REMARKS

This case has been carefully reviewed and analyzed in view of the Official Action dated 8 May 2002. The undersigned attorney would like to take this opportunity to thank the Examiner for the courtesies extended during the personal Interview held on 13 June 2002. Responsive to the rejections made in the Official Action, and the discussions held at the Interview, Claims 1, 3, 14 and 15 have been amended and Claims 2 and 11 canceled by this Amendment.

FIG. 12A

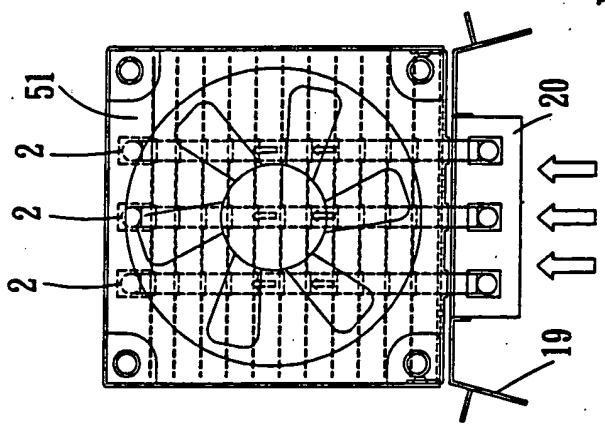
In the Official Action, the Examiner objected to the drawings under 37 C.F.R. § 1.83(a). The Examiner stated that the drawings must show every feature of the invention specified in the Claims, and therefore, the primary element and the expanding area must be shown or the features canceled from the Claims.

A red-lined copy of the drawings of FIGS. 12A and 12C are enclosed for the Examiner's approval. It is proposed to add the delineation of the expanding area, reference numeral "23" thereto. The embodiment of FIG. 12 is a variation on the embodiment of FIG. 1, wherein a plurality of the loops of FIG. 1 are connected in parallel, as described in the Specification, page 11, beginning on line 15. FIG. 1 clearly shows the inclusion of the expanding area. Thus, no new matter is added by this proposed drawing change.
